Subject: Review meeting 7/16/19 Lavitt property PV Planning from Phil Hagenah

Re: Preliminary Plat for Lavitt Manor II—Two Lot Subdivision: 7525 N. Ironwood Drive

5. PUBLIC HEARINGS 19-302 CONSIDERATION OF PRELIMINARY PLAT

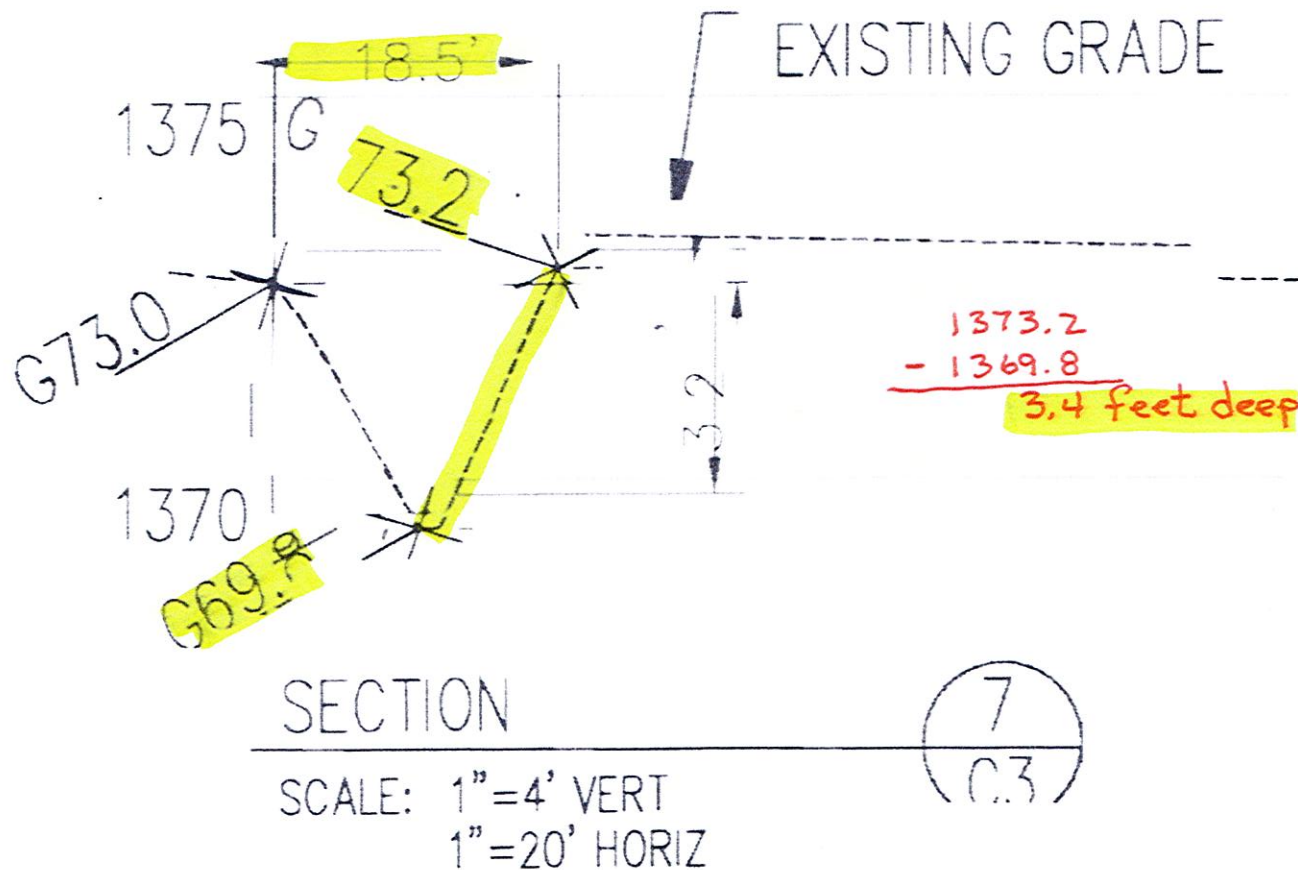
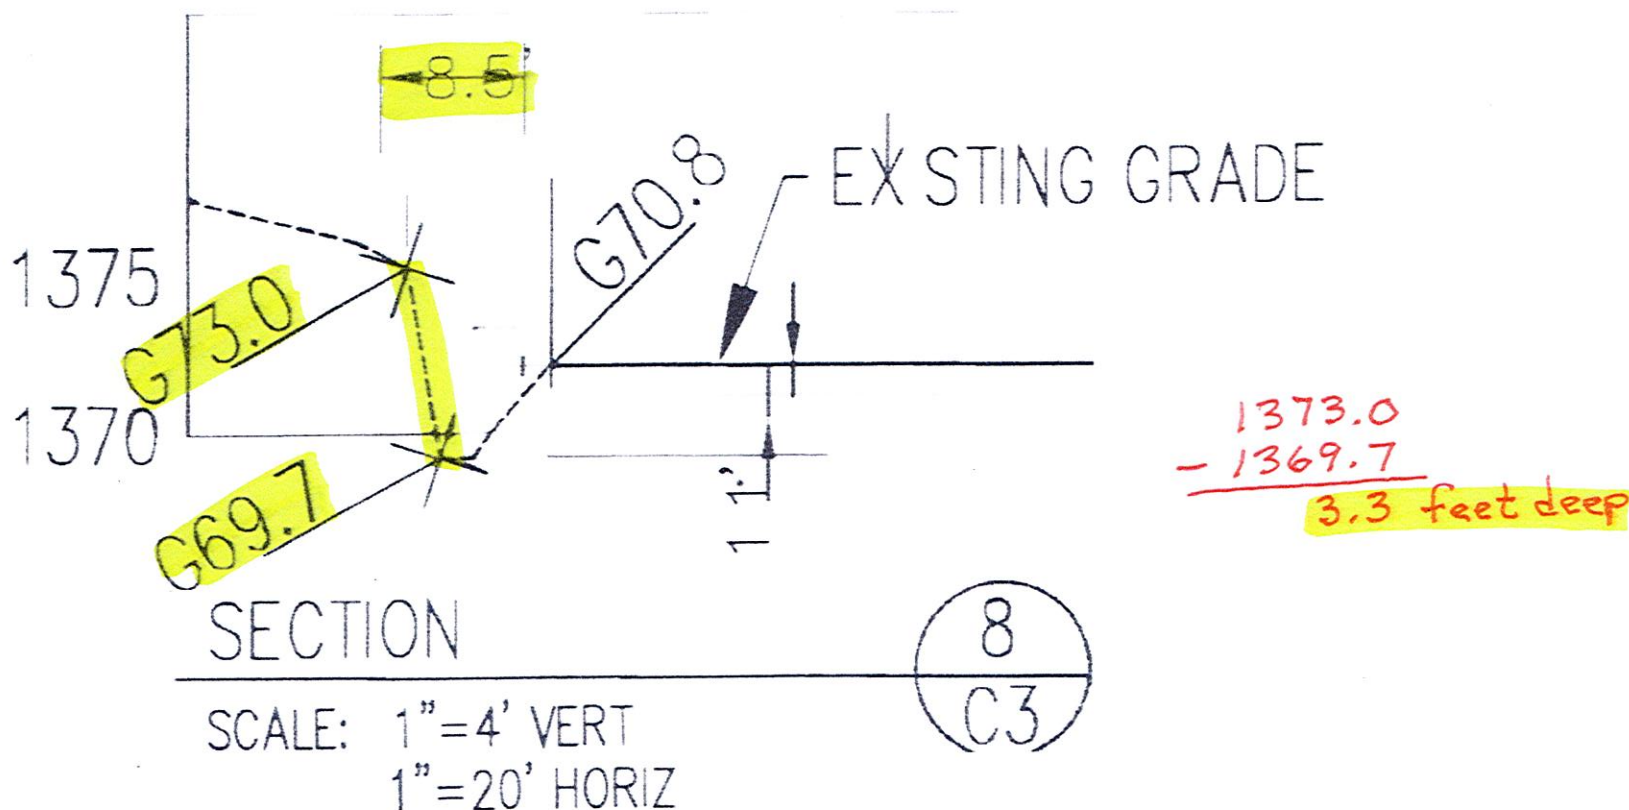
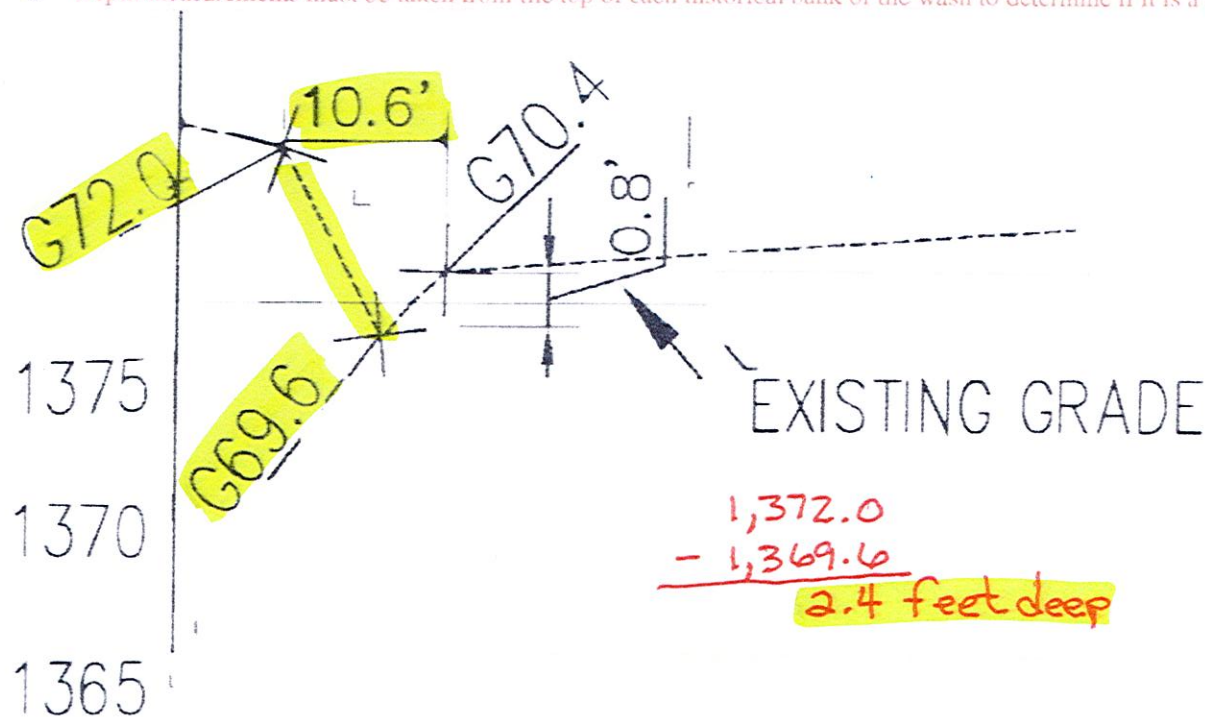
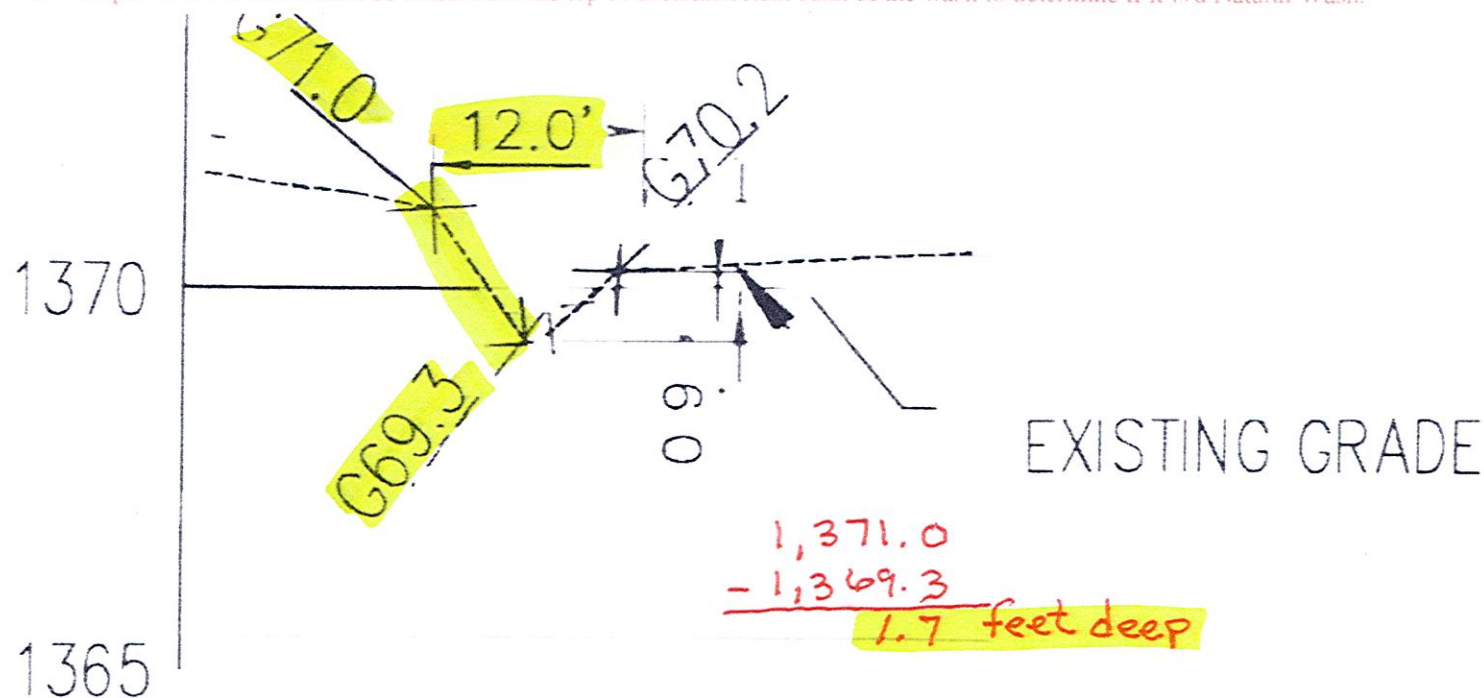
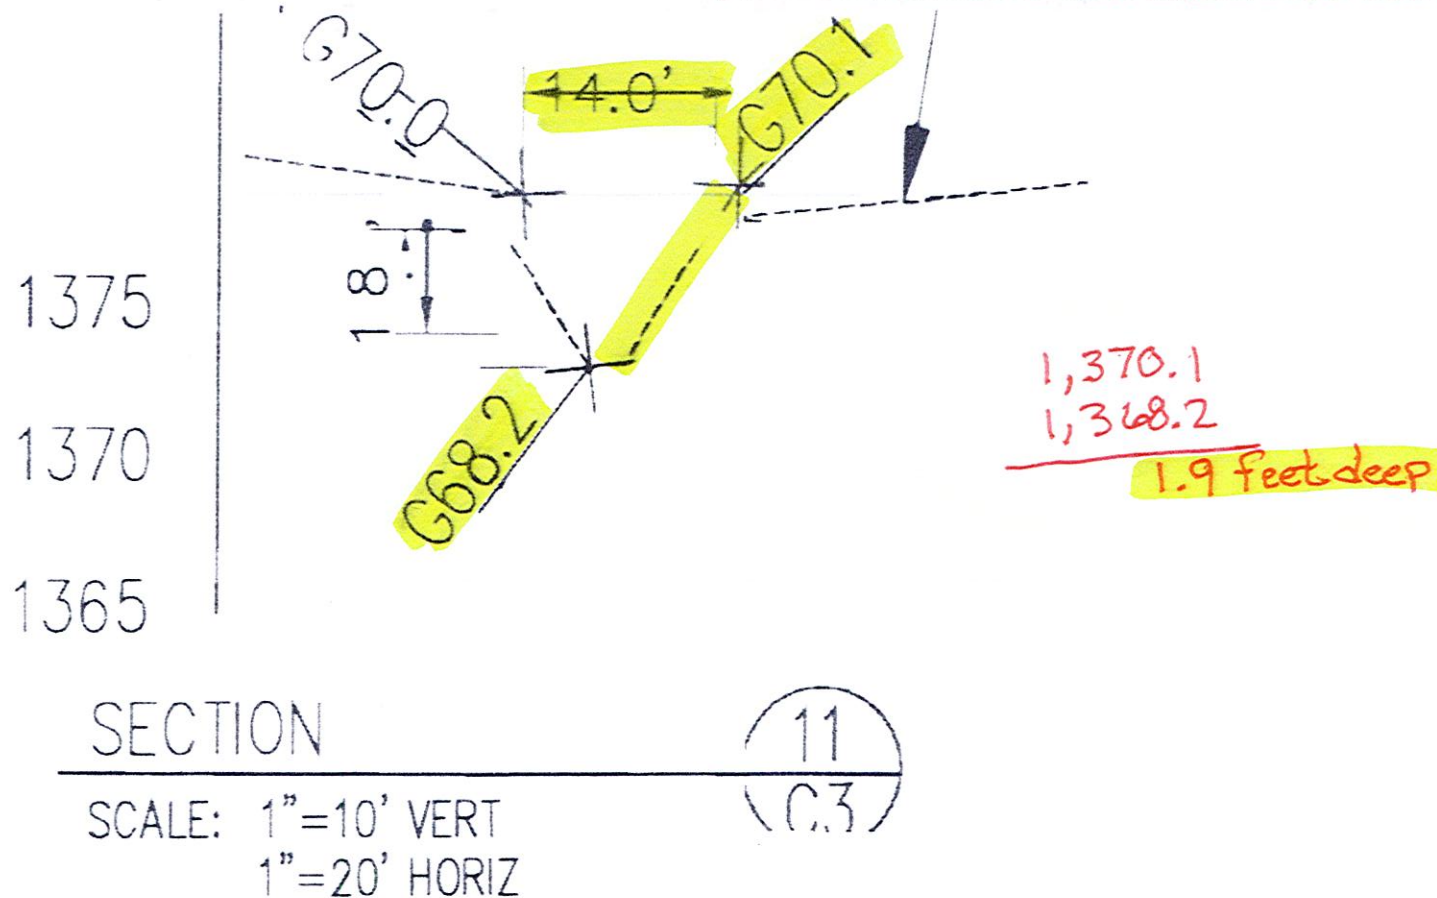
- Must consider both "historical banks" to determine depth;
- Nowhere does it say watercourse depth is taken from one bank, lowest bank, or existing grade of one bank.

- Width must be determined by taking a measurement at the "top of the bank":
 - Can only mean at the top of each bank, or one could not obtain a width measurement from one bank.
- Accordingly, to ensure the same "top of the bank" meaning throughout the provisions, "top of the bank" must mean top of each bank;
 - Depth measurements must be taken from the top of each historical bank of the wash.

- Width must be determined by taking a measurement "to the top of the bank":
 - Can only mean to the top of each bank, or one could not obtain a width measurement from one bank.
- Accordingly, to ensure the same "top of the bank" meaning throughout the provisions, "top of the bank" must mean top of each bank;
 - Depth measurements must be taken from the top of each historical bank of the wash to determine if it is a Natural Wash.

- Paving Grading Drainage Exhibit showing:
 - Topography showing top of the bank of each side of the southern wash;
 - Separate line showing 5 foot landscape buffer on each side of the top of the bank;
 - Separate line showing proposed easement that reflects all points of the new easement are outside the 5 foot landscape buffer.
 - Revised Drainage Easement and Drainage Easement Agreement being provided to the Town of Paradise Valley reflecting southern Natural Wash inclusion.

- Revised Preliminary Plat reflecting all of the above.
- Recommend Preliminary Plat reflect the actual buildable square footage in northwest corner of Lot1.

DRAWING NO:
C40f4

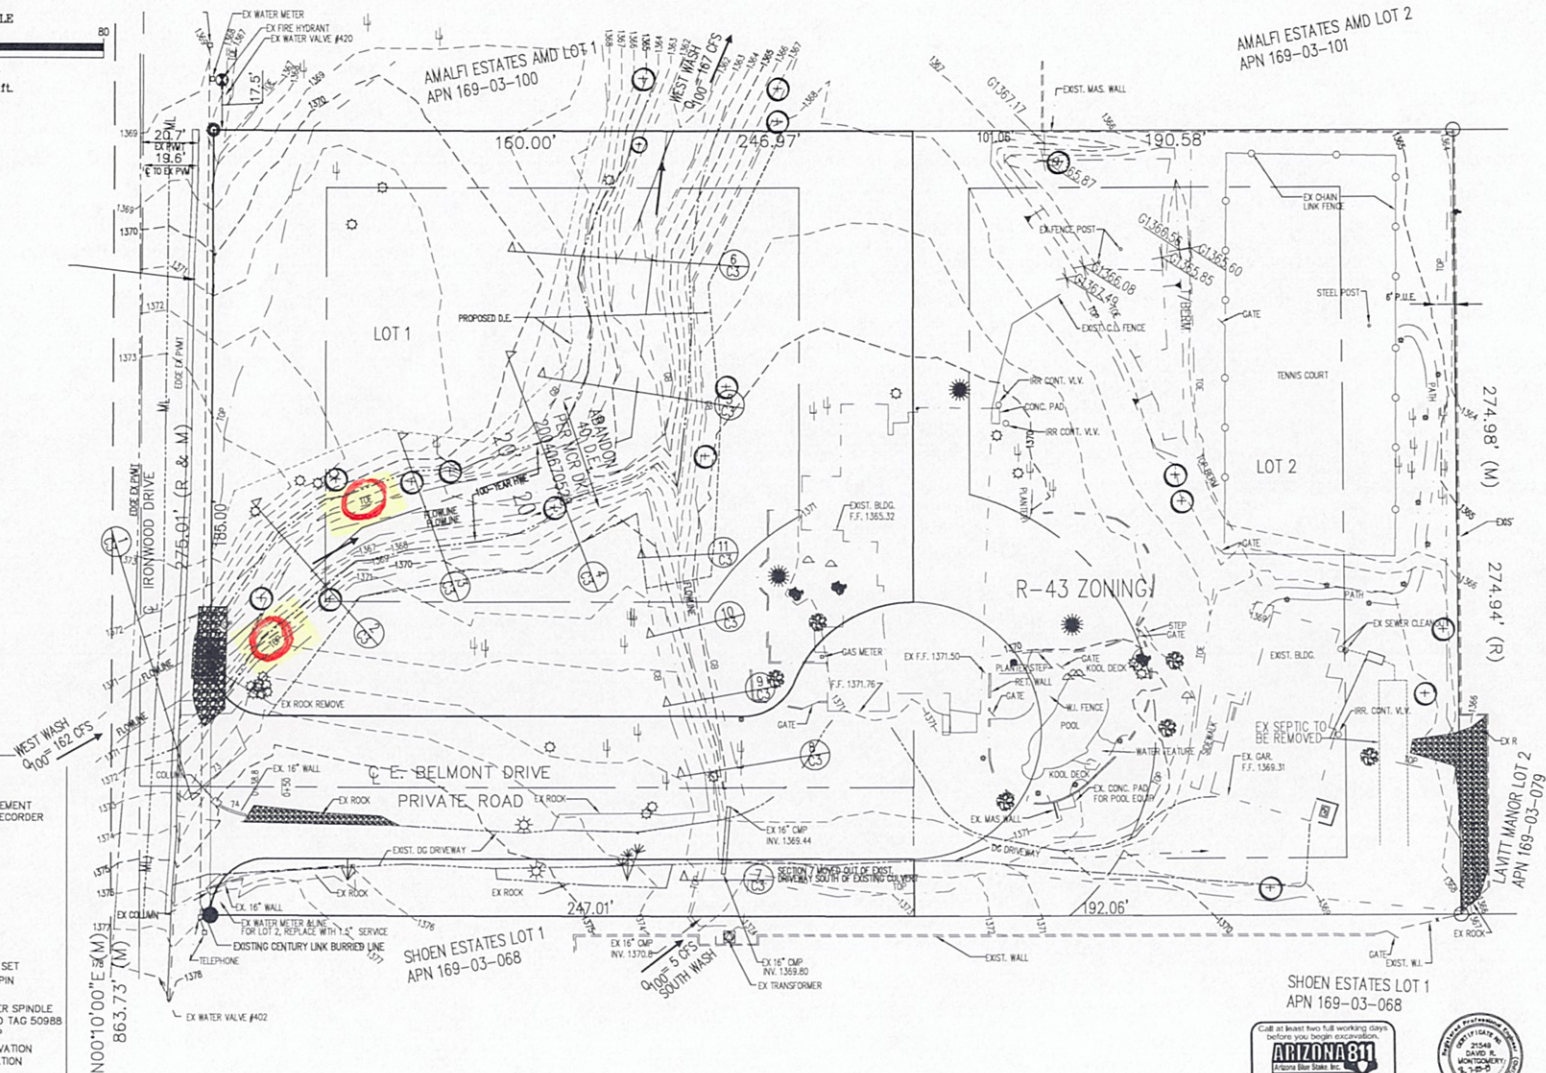
1. Impossible to track lines of “TOB” on the plat.
2. Does not show required 5 foot “landscape buffer” that is required to be “perpendicular from the top of the bank.”
3. Cannot tell whether proposed easement conforms with the Storm Drainage Manual
